PROJECT NAME
Alpine Street Garage

PROJECT ADDRESS
11-15 ALPINE STREET
SOMERVILLE, MA

REVISION TO ZBA 2016-75
September 16, 2021

List of Changes; Refer to Accompanying Narrative.

A-300B

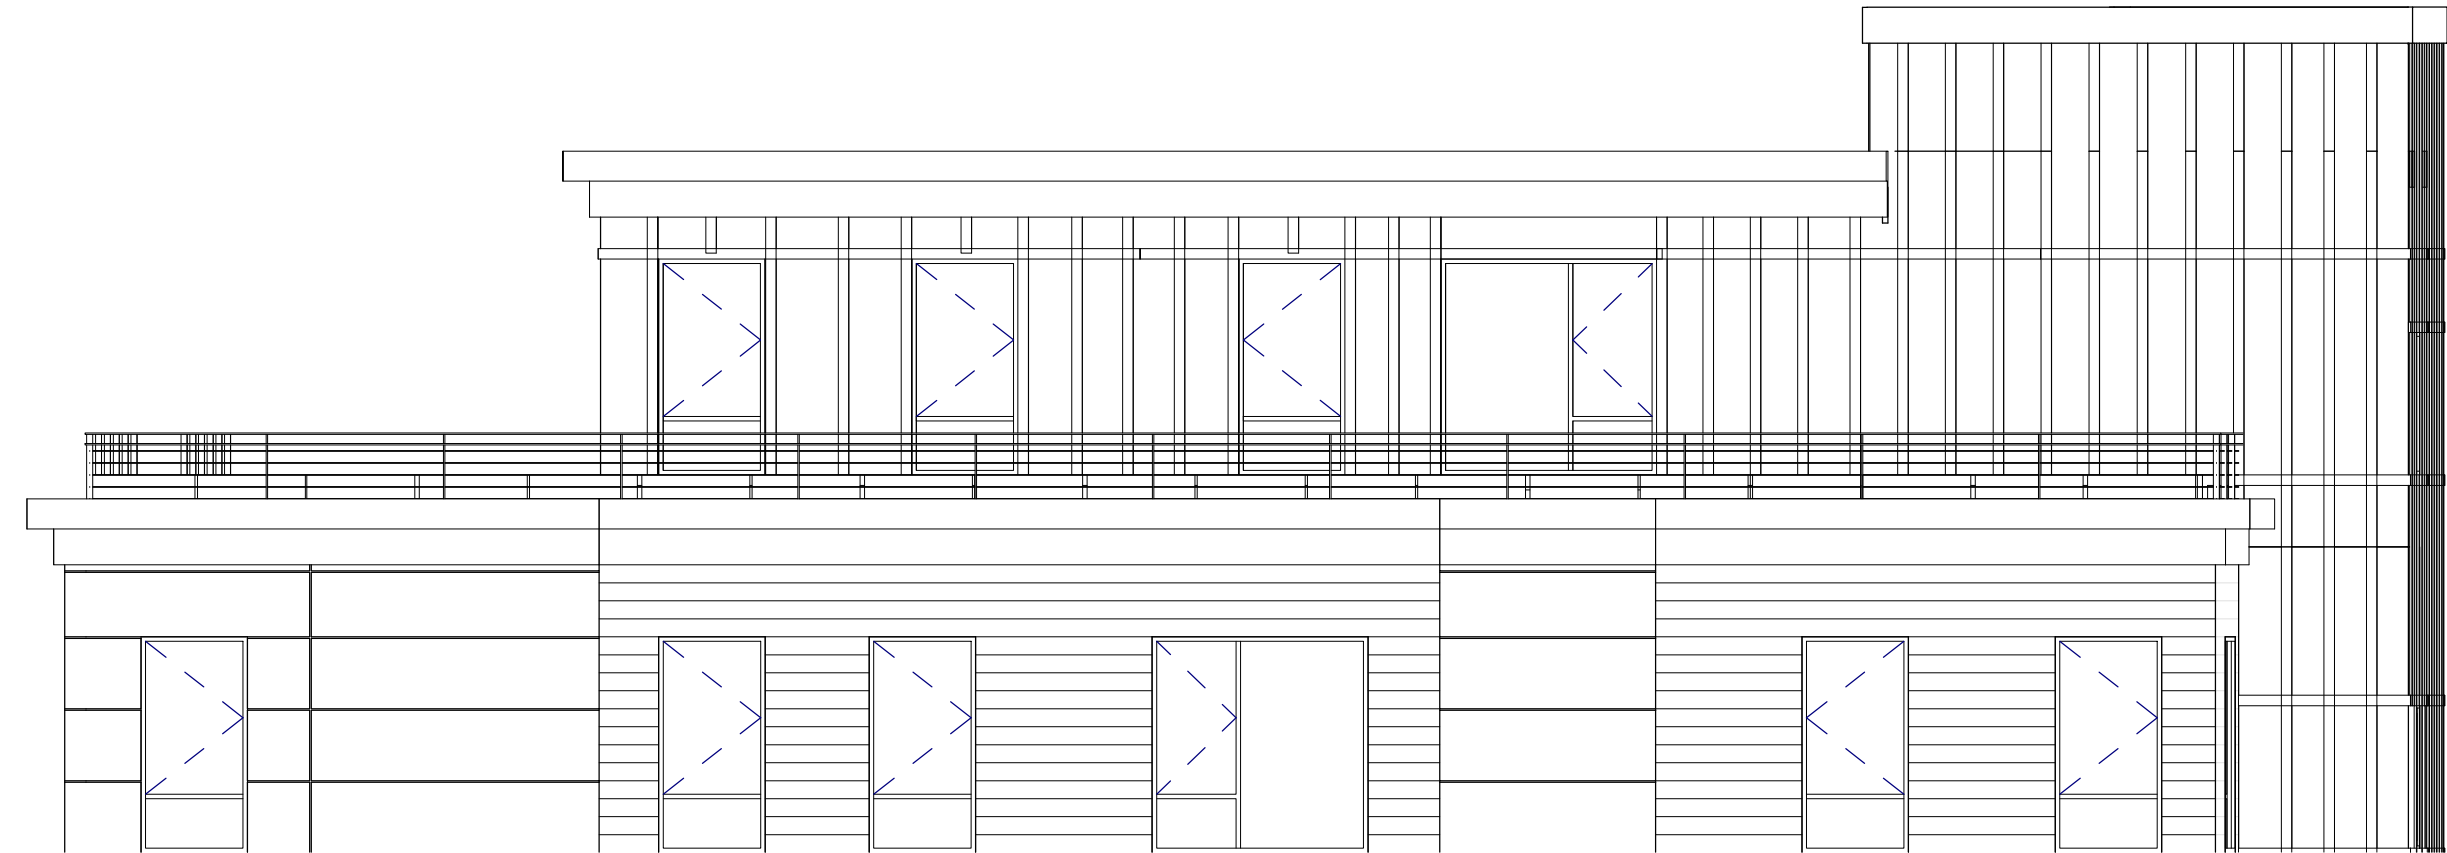
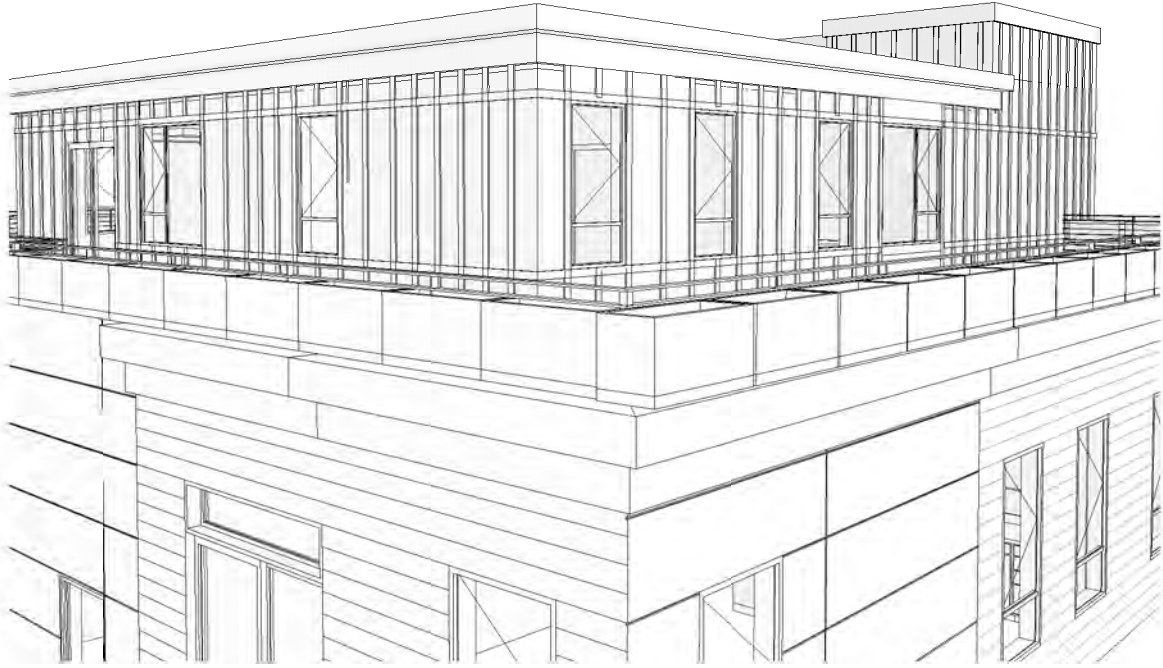
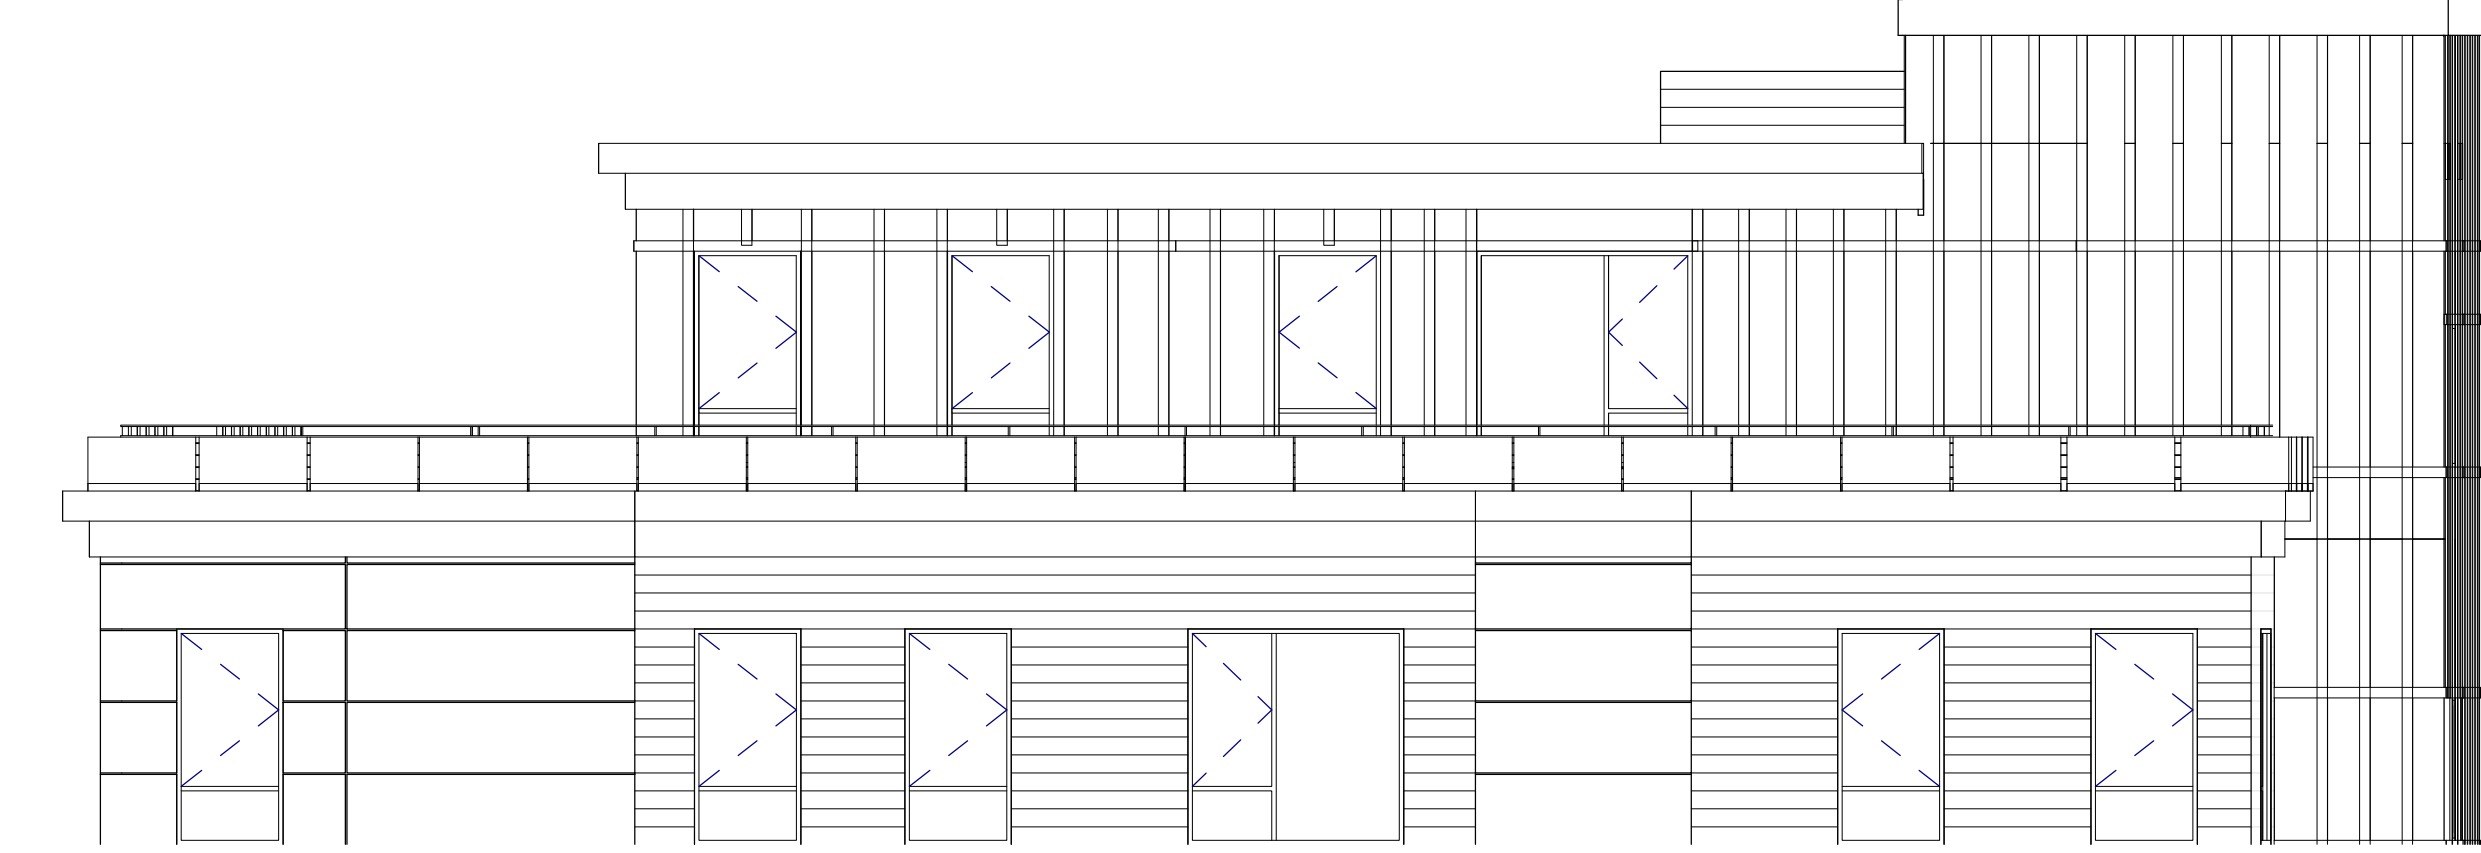
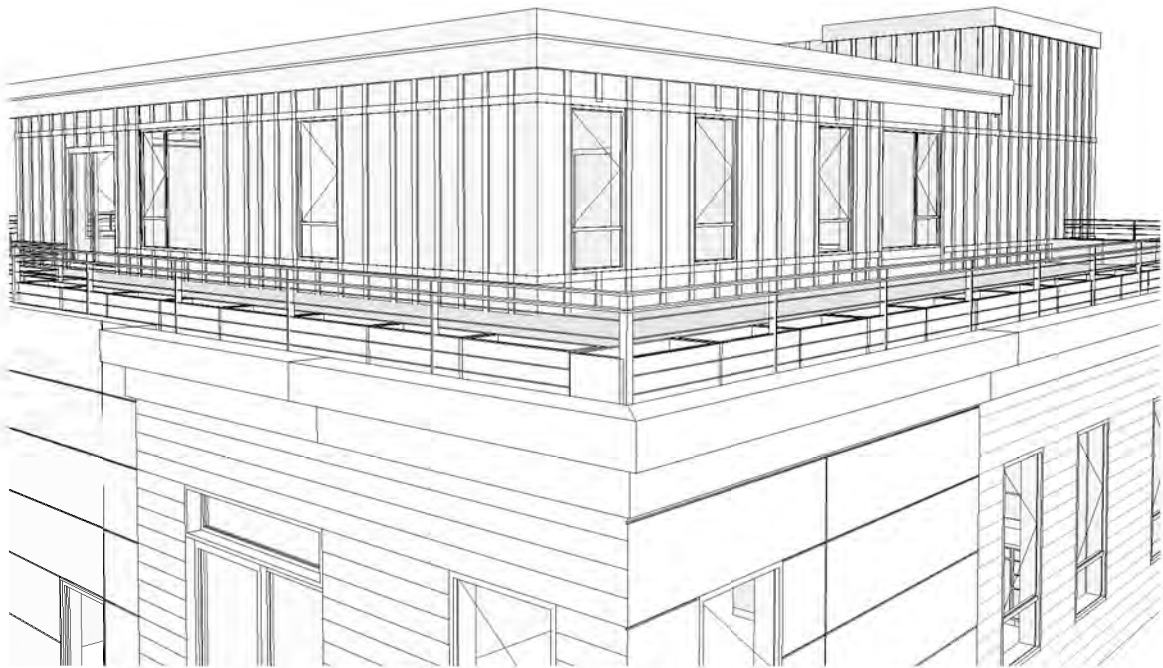
11. The wood decking is being extended to three sides of Unit 401 on the 3rd floor roof (a/k/a the fourth floor deck), thereby creating a larger balcony. Additional planters and florals are being proposed to help create a bee habitat. Three options are being proposed:
A. Mount the railing on top of the parapet wall and construct a raised planter at the inside of the railing, or

B. Place the railing inside of the parapet wall on the deck and place planters on the parapet wall up to railing height to address neighbor's privacy concerns, or

C. Place railing inside of the parapet wall on the deck and place planters inside of the railings on the deck

A-301

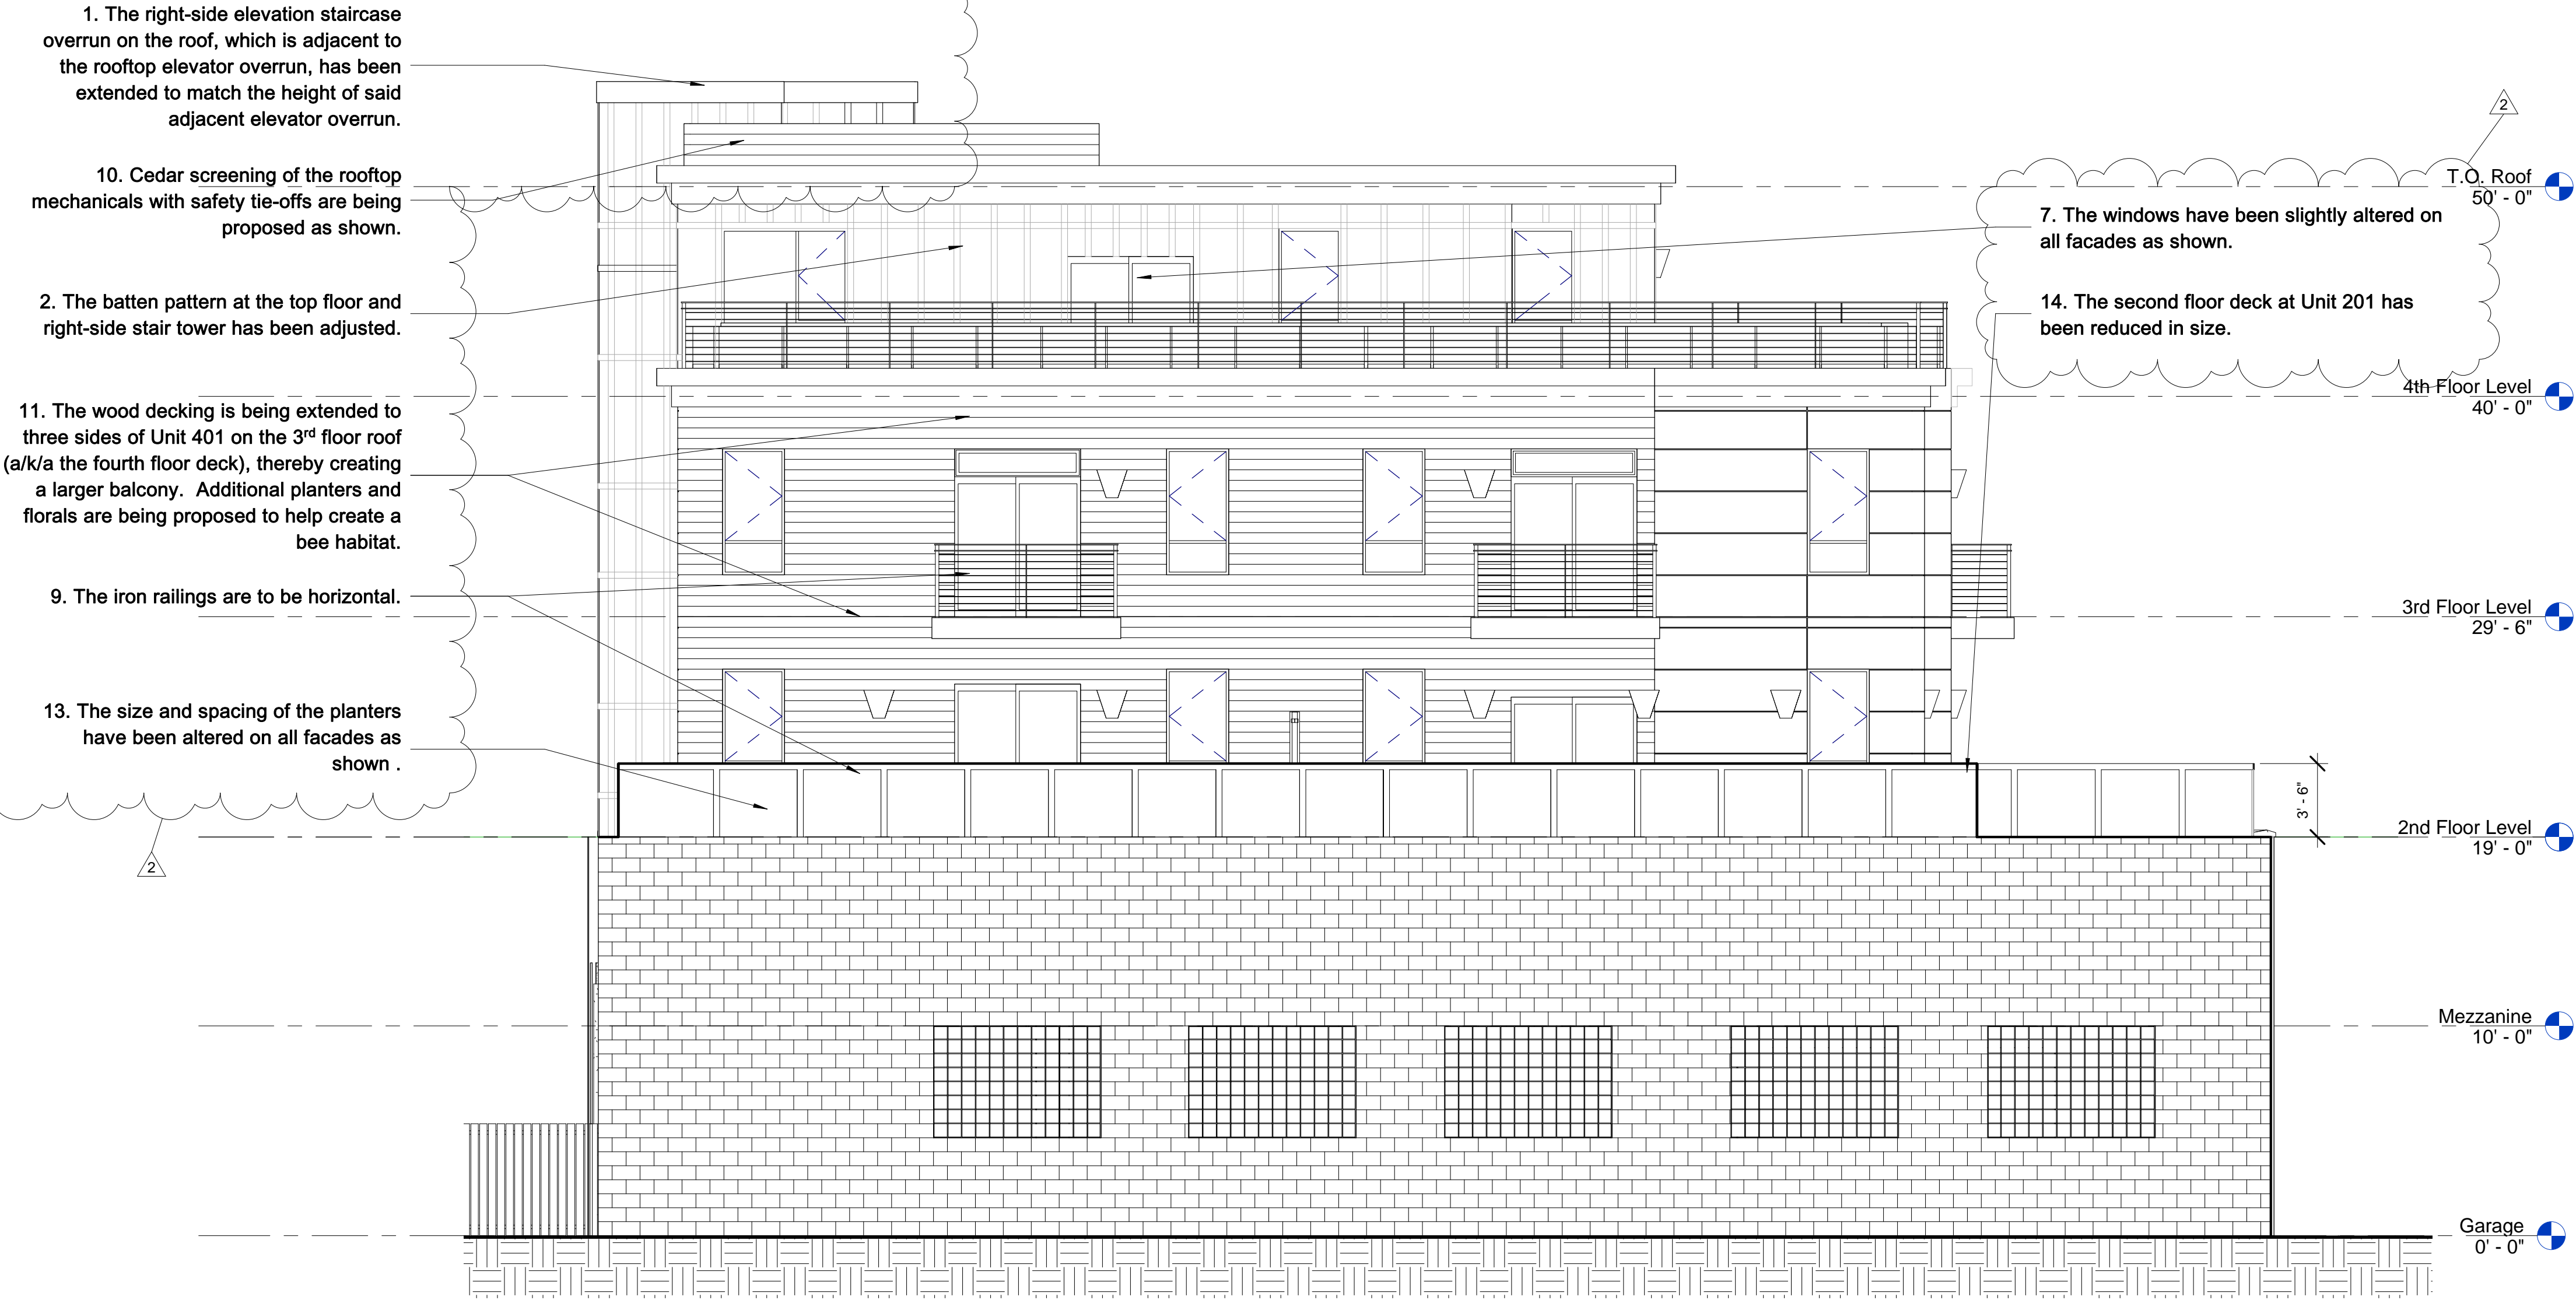
10. Cedar screening of the rooftop mechanicals with safety tie-offs are being proposed as shown.

2. The batten pattern at the top floor and right-side stair tower has been adjusted.

9. The iron railings are to be horizontal.

7. The windows have been slightly altered on all facades as shown in the elevations.

5. CMU block is to be used on the Easterly wall.

USE OPAQUE OR TINTED GLASS AT WINDOWS ON LOT LINE
